Resolution of the Task A-11 Reactor Vessel Materials Toughness Safety Issue

**Part I - Main Report, Part II - Staff Responses to Public Comments,
and Appendices A and B**

**U.S. Nuclear Regulatory
Commission**

PART II Staff Resolution of Public Comments

Figure 5.1 Schematic Curves of $J=f(T)$ Illustrating the Material and Structural (Applied) Curves the Intersection Denoting Instability.

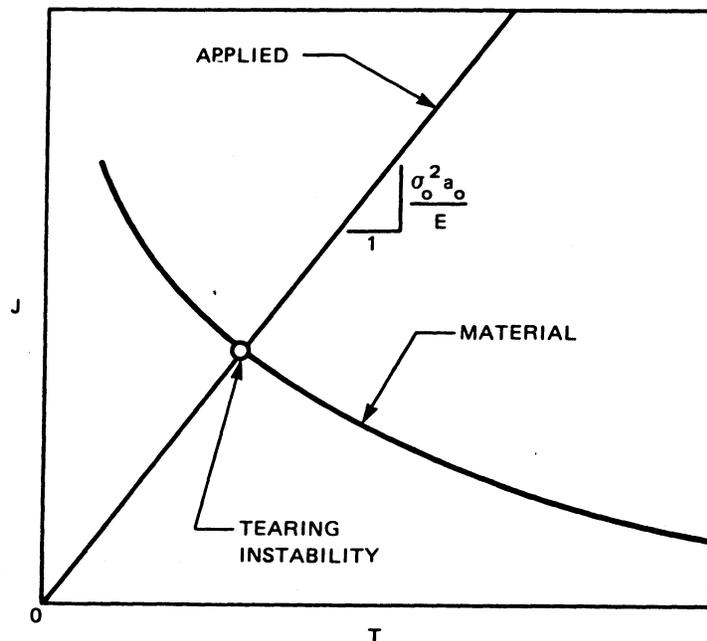
Comment 43: Pg 5-2: Figure 5.1 should show J_{IC} .
(Specific)

Resolution: Showing J_{IC} on Figure 5.1 is not germane to the purpose, which is to illustrate, schematically, the way to determine crack instability (the onset of test fracture) under conditions that can be analyzed with applied elastic-plastic fracture mechanics. In fact, it would be a distraction. Also, the current methods for determining J_{IC} involve data reduction to obtain two straight lines--the blunting line and a linear representation of the J-R curve between the exclusion lines. The schematic material curve of Figure 5.1 would not accommodate the two straight lines and, at the same time, serve the author's purpose, which is to emphasize the nonlinearity of the J-R curves.

Figure 5.2 J-R Curves From a Low USE A-302B Steel Showing No Size Effect Between 0.5T and 1T CT Specimens at 25°C.

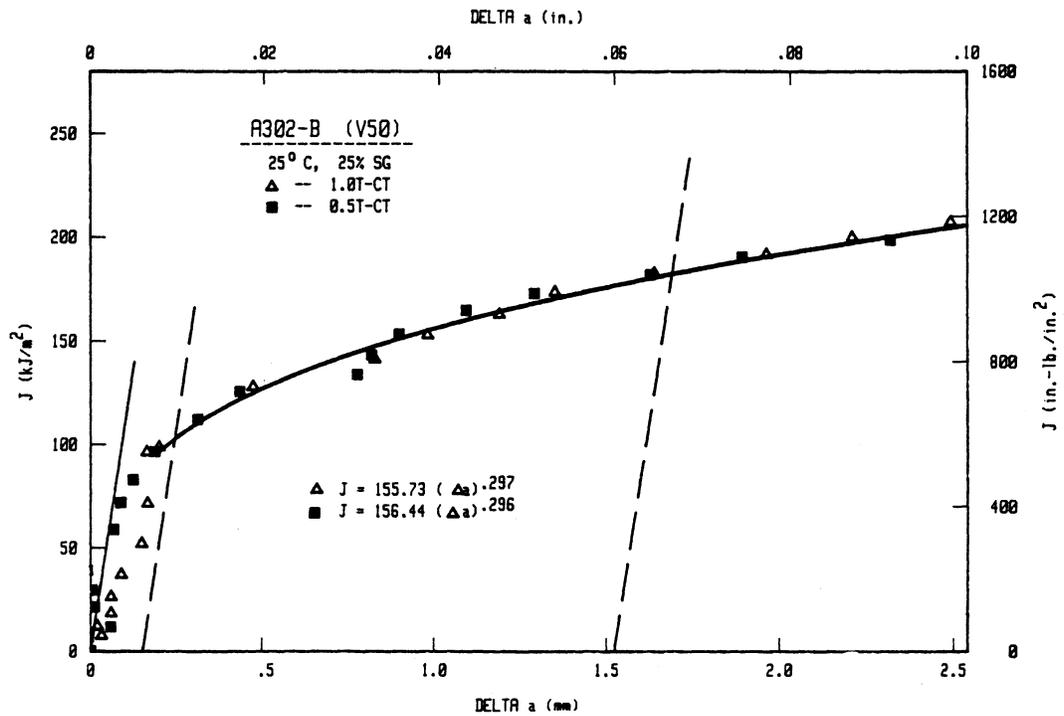
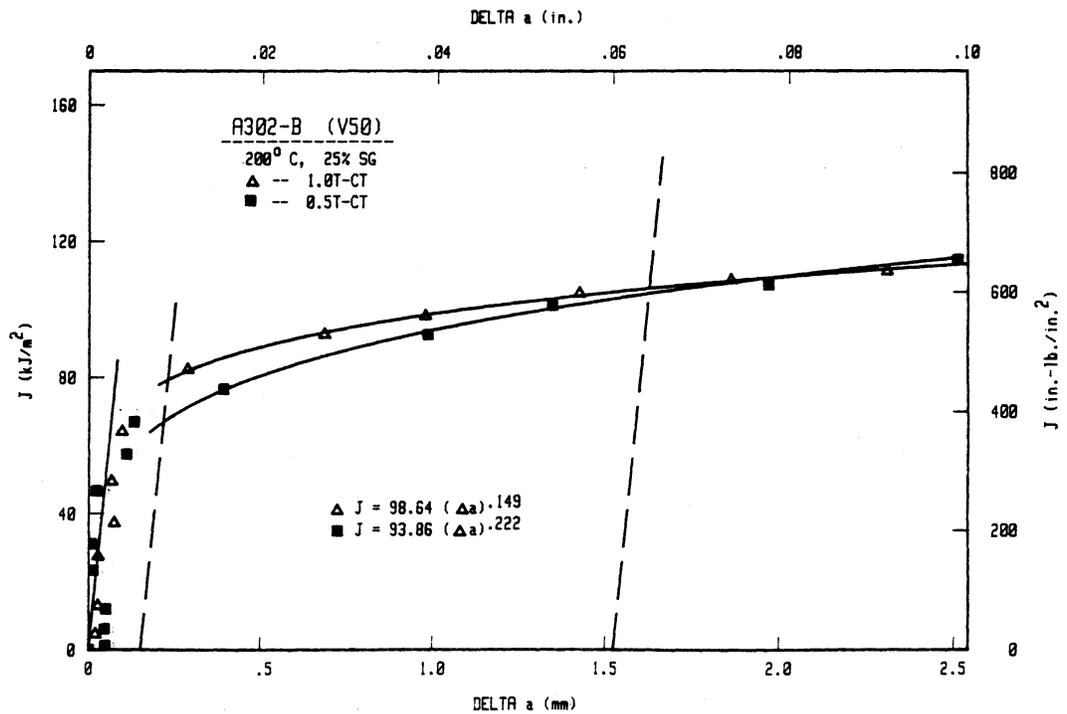
Comment 46: Figures 5.2 and 5.3: These should be credited as NRL data.
(Specific)

Figure 5.8 HSST Intermediate Pressure Vessels Test Data

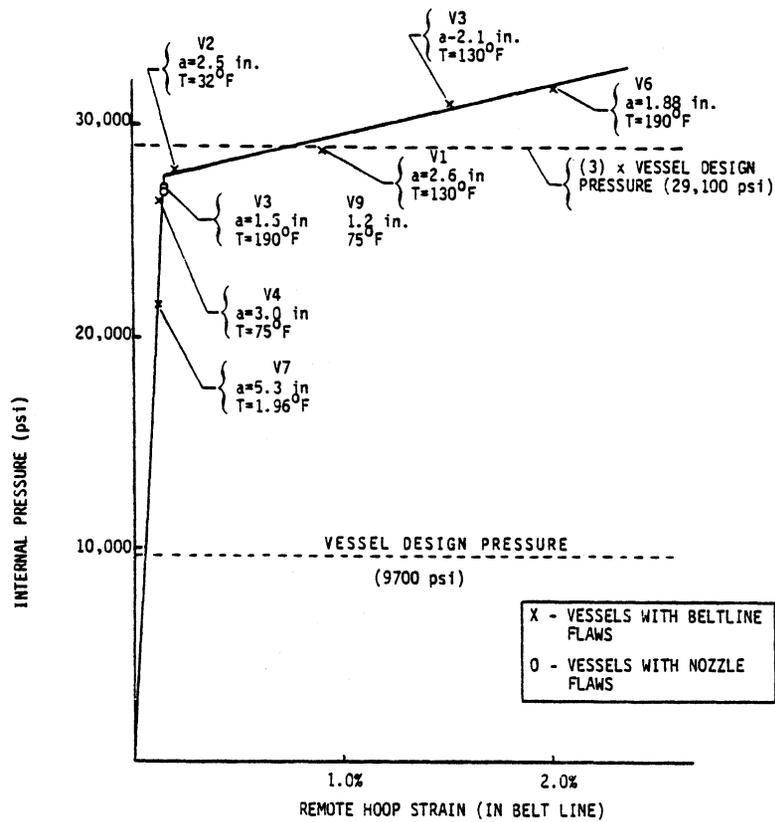
Comment 54: What is the basis of the pressure-strain curve in Figure 5.8? How does one construct such a diagram for an actual pressure vessel?
(Specific)

Resolution: The $P-\epsilon$ curve of Figure 5.8 was based on measurements taken at failure of the ITVs noted. It is a reprint of Figure 2, Appendix H. The text accompanying that graph in Appendix H should be read. Because the curve was constructed using data from several vessel

Figure 5.9 J_{mat} Vs. T_{mat} Curves of Figure 6, Appendix H

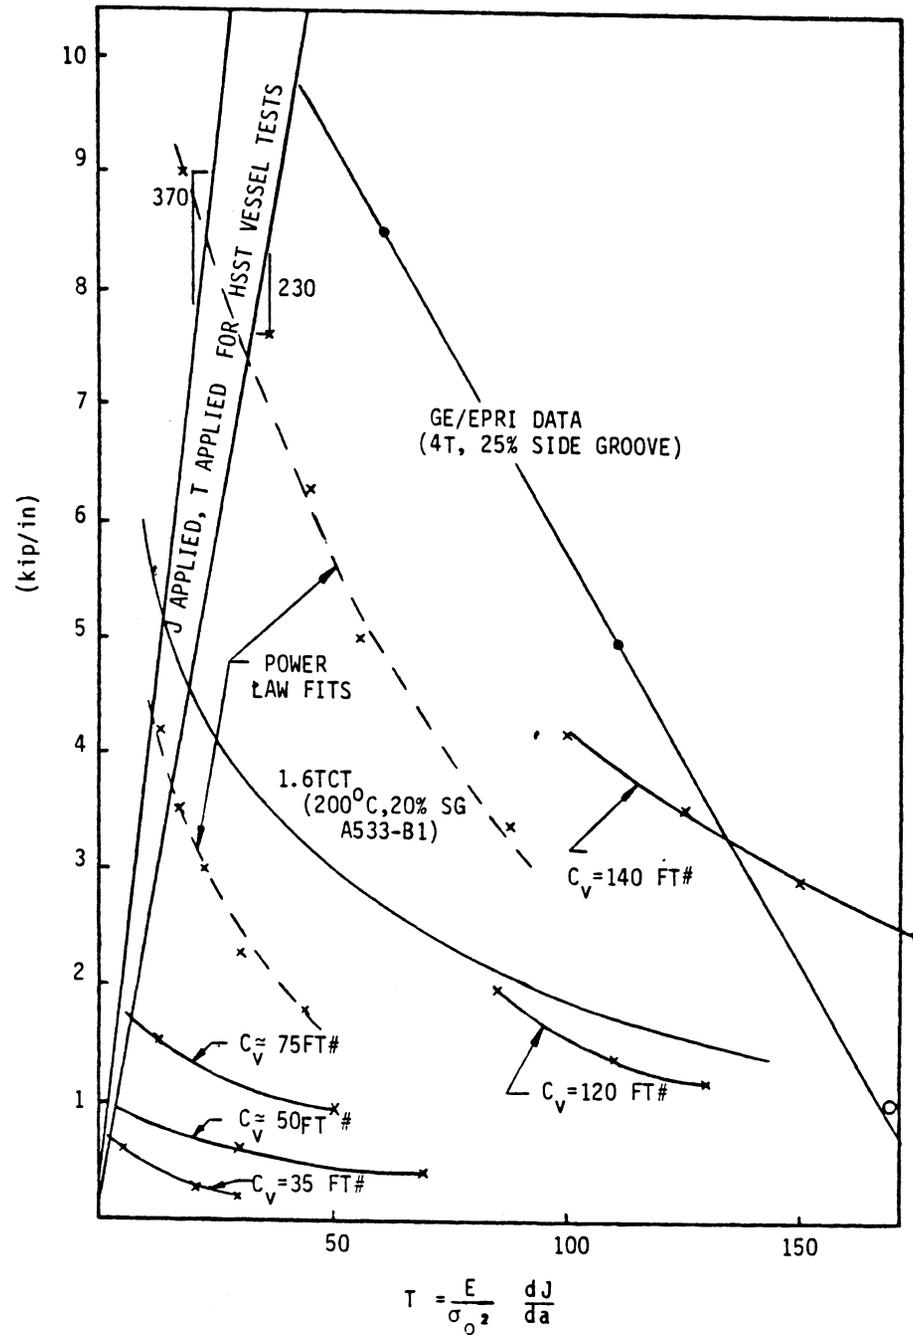
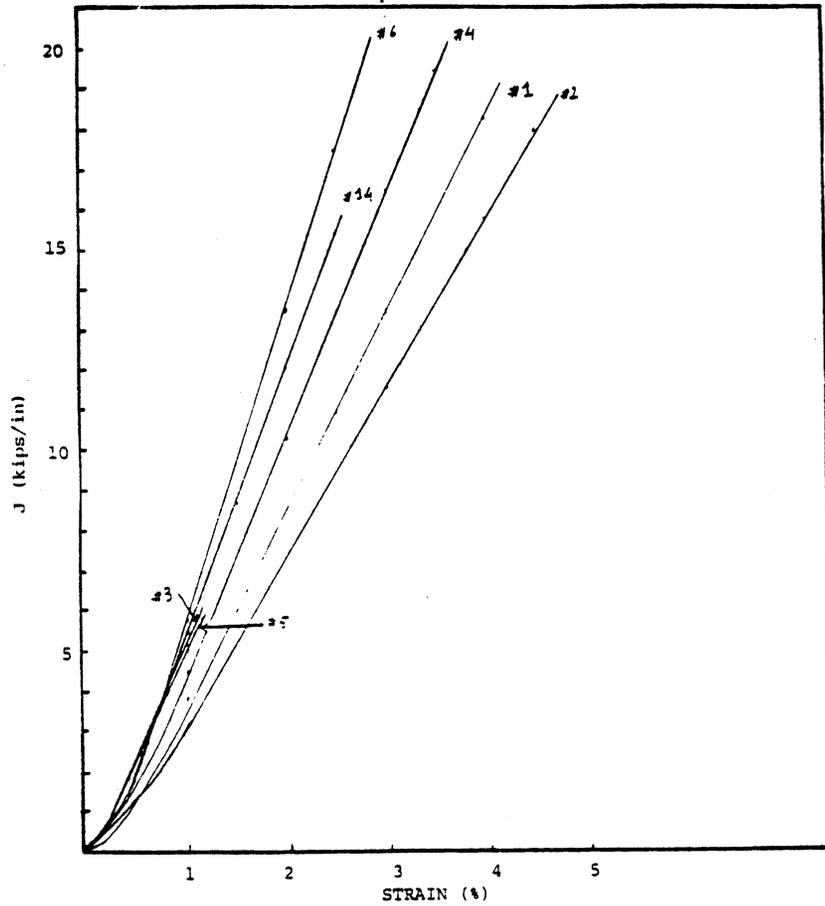
Comment 47: Figures 5.9 and 5.11: The upper line labeled "GE/EPRI Data" may be too high based on estimates by Loss and Berggren. It should be determined whether the GE experimental data contain a correction for crack extension. This correction will lower the J-R curve. In addition, the NRL data are for 200°C. It is known that the R curve falls with rising temperature. This fact is not mentioned in the comparison with vessel tests.
(Specific)

Figure 5.12 J Vs. T Curves for the Large Tensile Specimens Corrected for Plane Stress

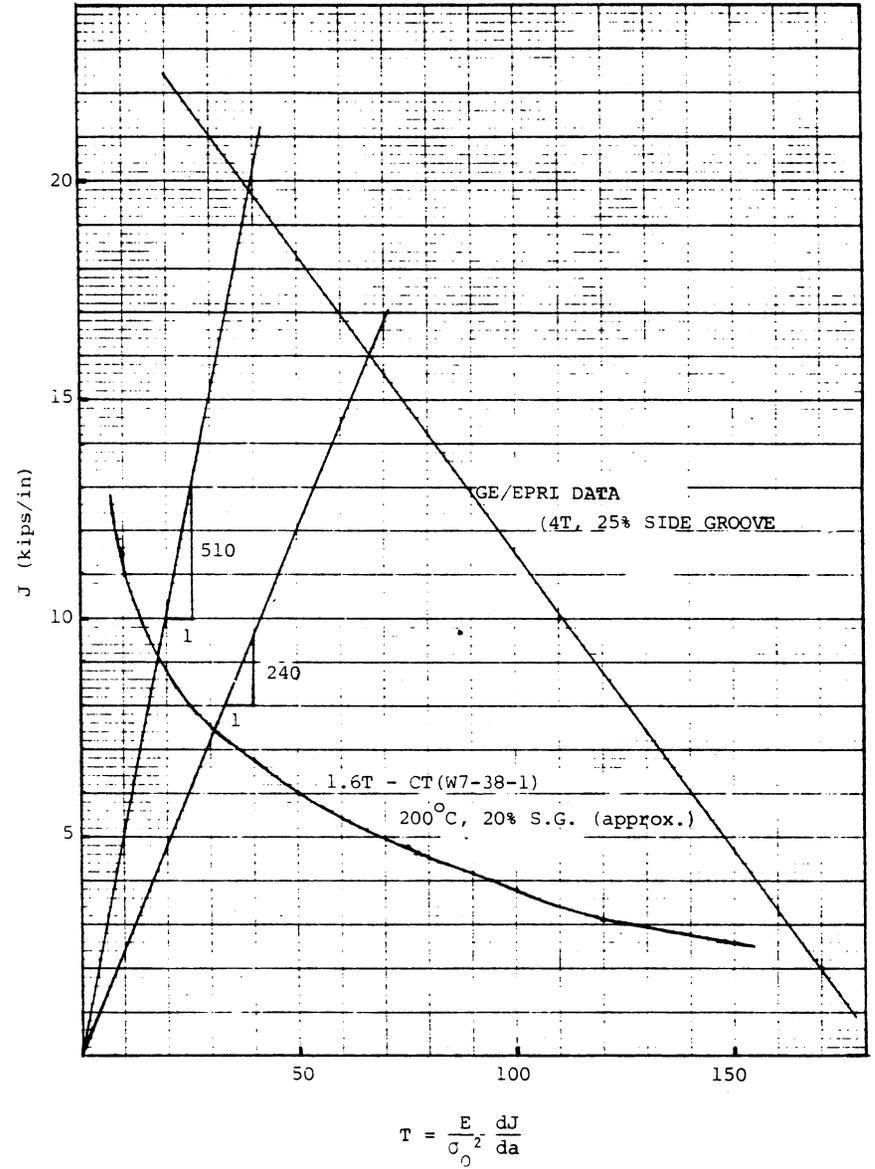
Comment 48: Pg 5-18: What is a "coupled J value"? Where is it shown on
(Specific) Figure 5.12?

Figure 5.13 Correlation between J (at the intersection of the $J/T = 50$ in.-lb/in.² load line and a materials curve) and the corresponding Charpy upper shelf energy value

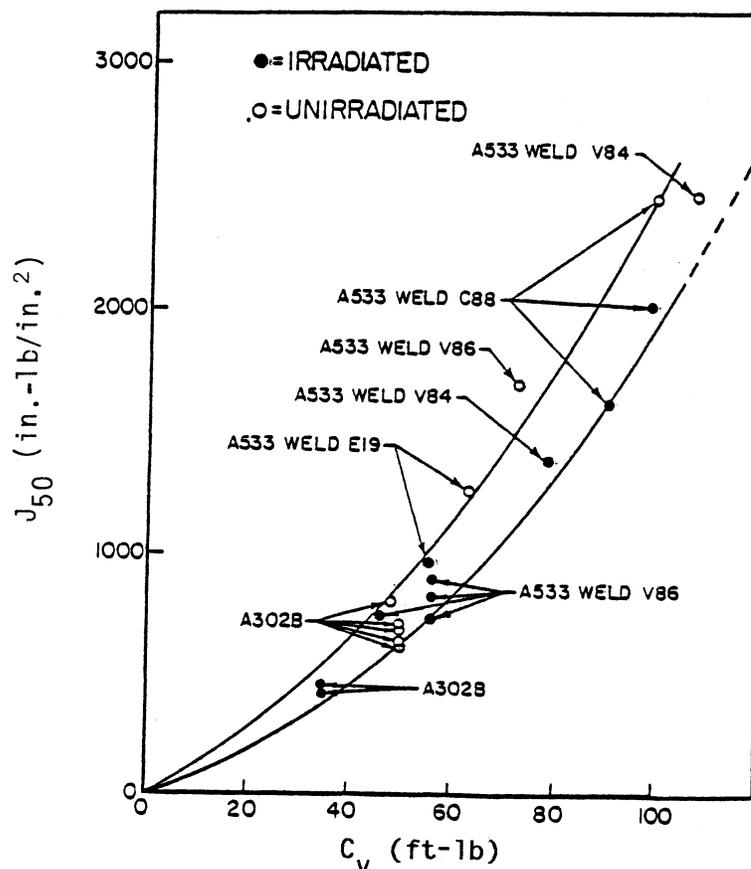
Comment 9c:
(General) Pg 5-21 and Figure 5.13: NRL should be credited for the original concept of a C_v -J correlation. Note that the correlation applies only at 200°C and that the R curve varies inversely with temperature. A more up-to-date correlation is Figure 11 of the ASTM Philadelphia paper by Loss or Figure 14 of the NRC information meeting.

Comment 49: Pg 5-22, Figure 5.13: Is this the preferred figure or should
(Specific) Figure 14 on pg D-23 be used? The latter was used in Appendix I. In the title to this figure, the words following "correlation" should be deleted.

Comment 50a: The units for J in Figure 5-13 are wrong. The implications of
(Specific) this figure should be discussed in some depth, because it appears to be a key figure with regard to the proposed analysis.

Comment 50b: Pg 5.22, Figure 5.13: In the title to this figure, the words
(Specific) "for Leak-Before-Break" should be deleted.

Resolution: The graph shown on pg 5-22 of NUREG-0744 is the one intended for Figure 5.13. It is not clear what was meant by the idea of "preferred" in the question. The lower bound correlation that is preferred as a part of an RPV analysis at any point in time will be that which is based on the most extensive collection of accurate, relevant data. The sentence on pg 5-22 that precedes Figure 5.13 addressed that point. The figure title has been changed.

Resolution: The problem with the units is a typographical error. It is believed that there is enough discussion of the implications of Figure 5.13, when all the discussions in the appendices are considered.

Figure II-1. Plot of strain rates (ϵ/ϵ_{ys}) versus the stress function $[F(\sigma/\sigma_{ys})]$ for the strain ranging from 0.003 to 0.013

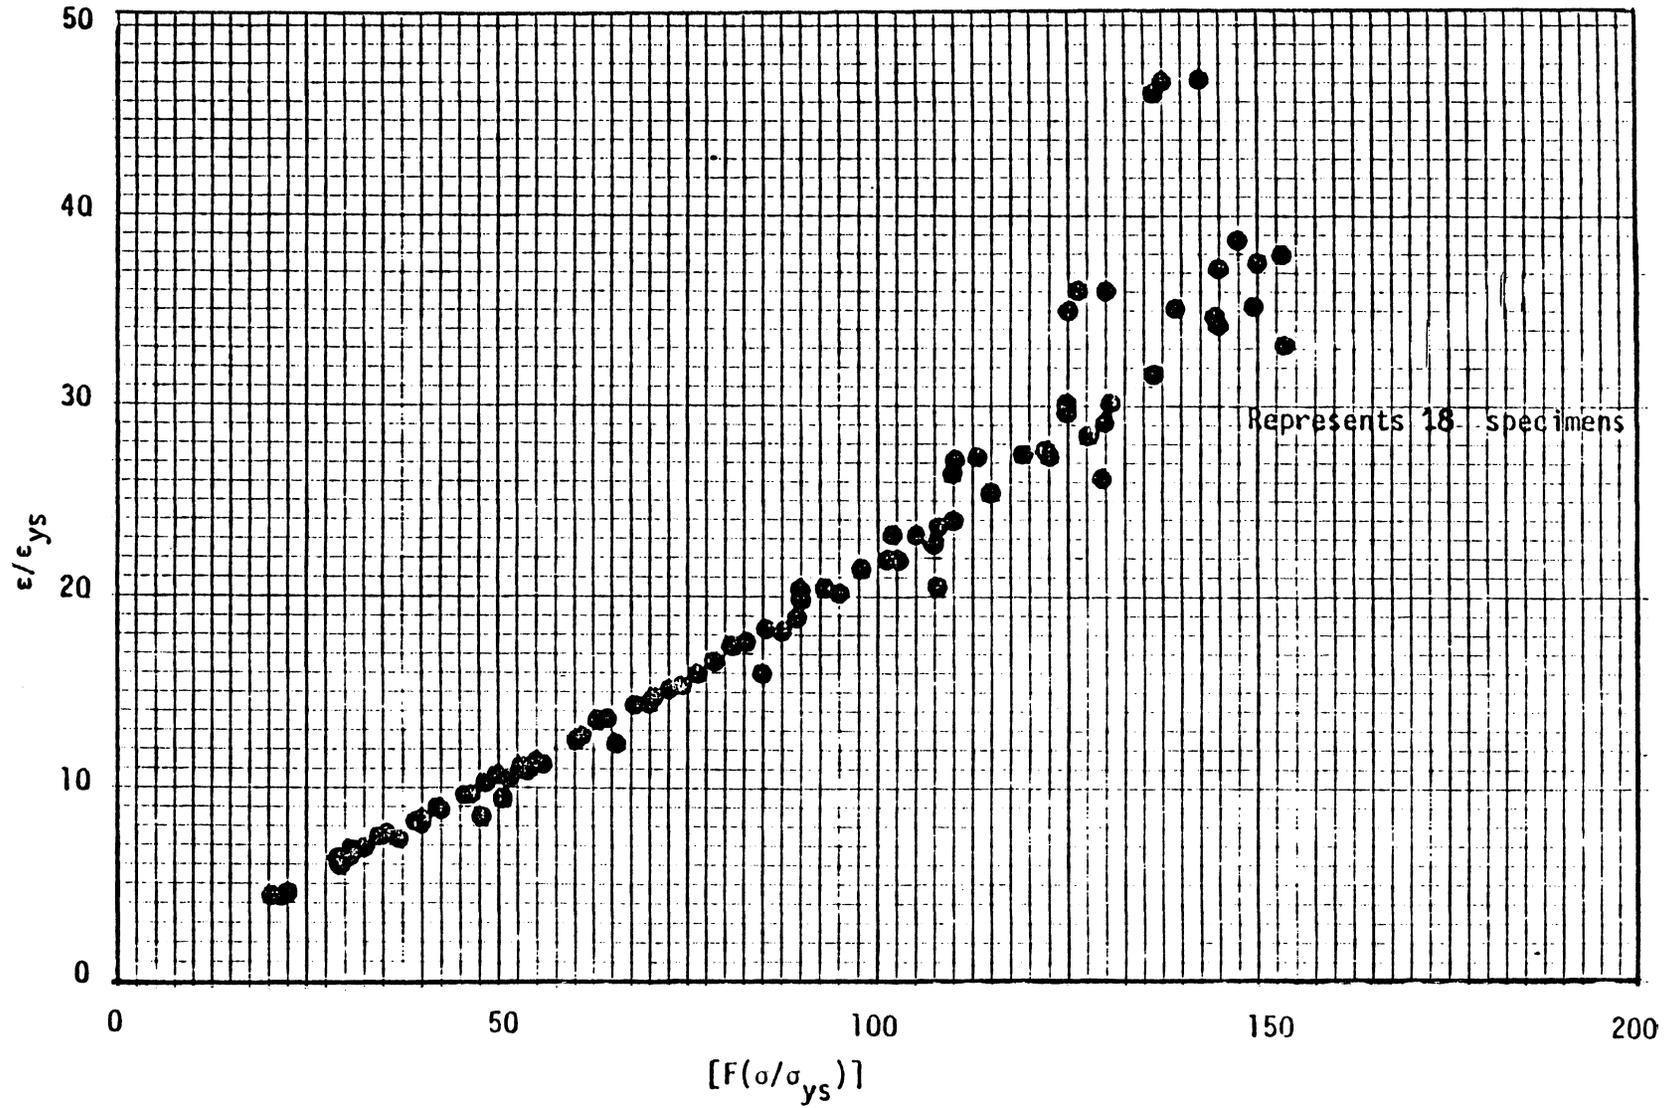
Pg H-6, Table 2: There is general agreement with ϵ/ϵ_0 in Table 2 and Figure 5 (pg I-32) at small values of the stress correction term. There is a substantial difference between (ϵ/ϵ_0) results in Table 2 and those shown in Figures 3 a-c and 4 a-c (pg I-30 and 31) for large value of $[F(\sigma/\alpha_0)]$. The difference may be a result of the strain range over which the Ramberg-Osgood equation was solved or a result of engineering stress-strain being used instead of true stress-strain. An example of a plot of ϵ/ϵ_0 versus $[F(\sigma/\sigma_0)]$, based on engineering stress-strain, is shown in Figure II-1 below.

Resolution: The correction has been made.

Figure 14 An attempted correlation of J_{50} values with Charpy upper shelf values from data by Loss

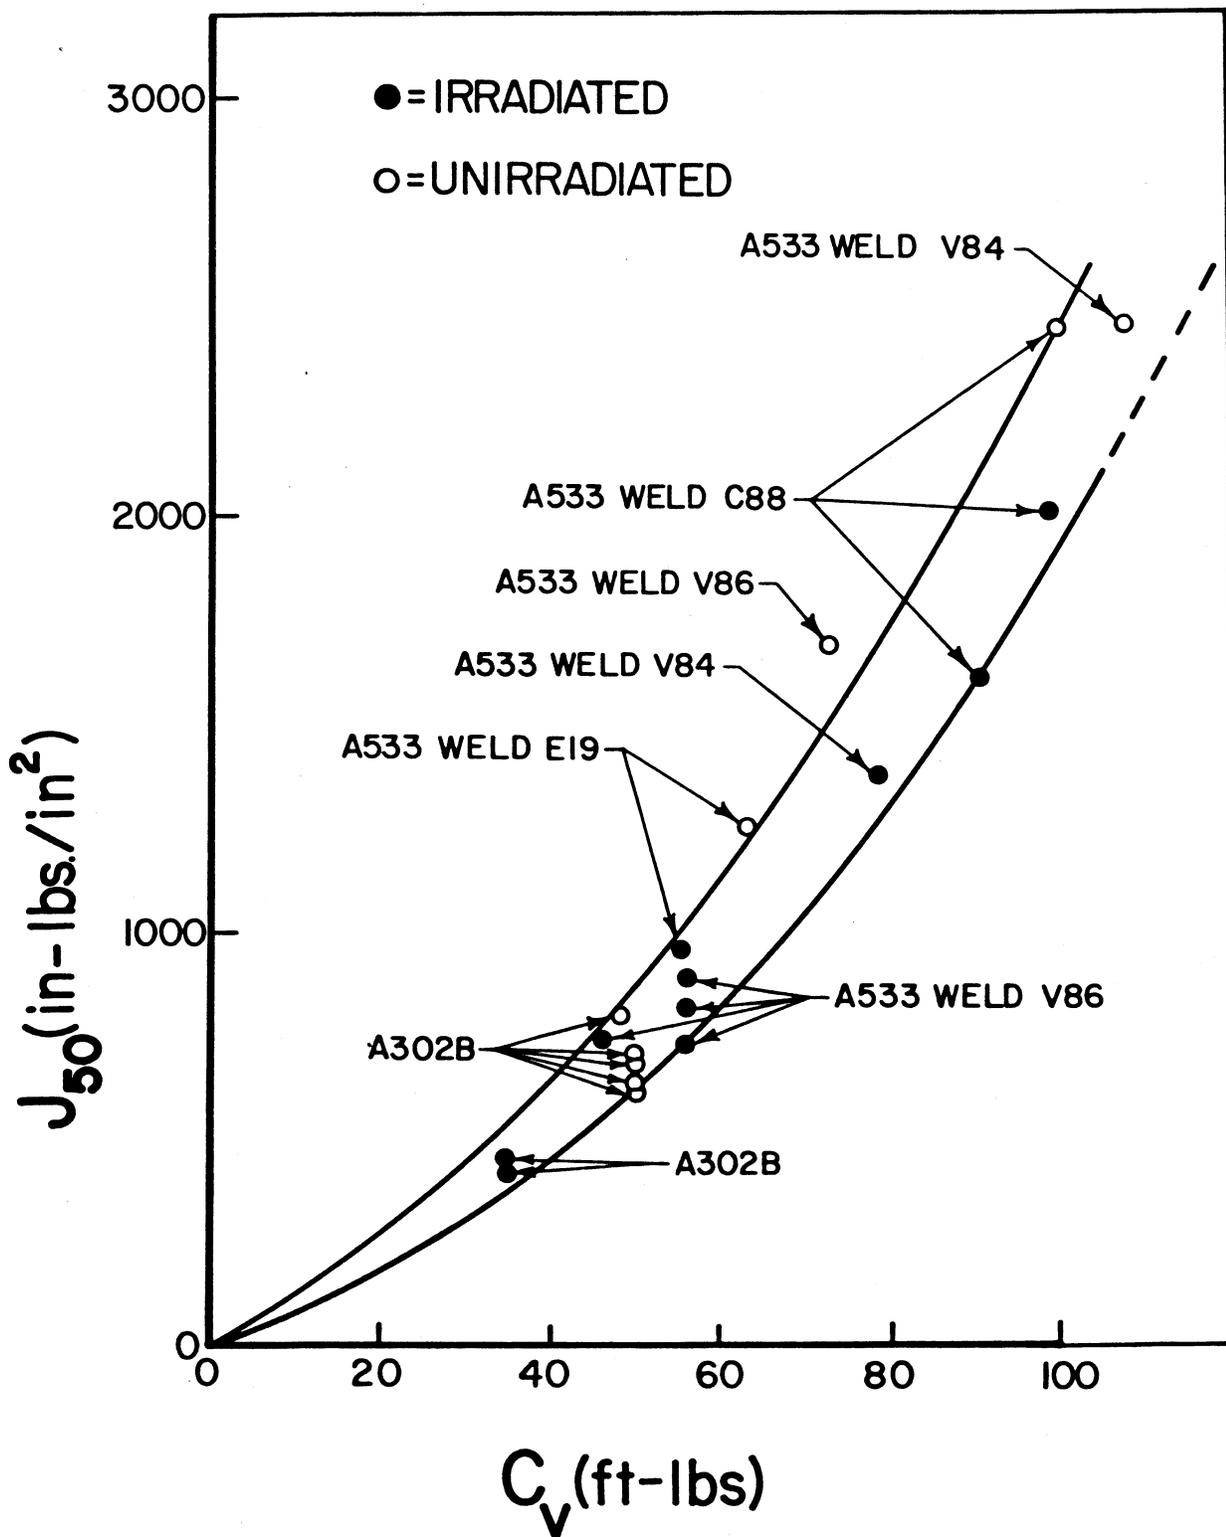
- o Absent plant-unique property curves, "the lower bound J (at $J/T = 50$) = $f(\text{USE})$ curve" is to be used. Which of the two different curves in the NUREG is preferred (Figure 5.13 or Figure 14 on pg D-23)?
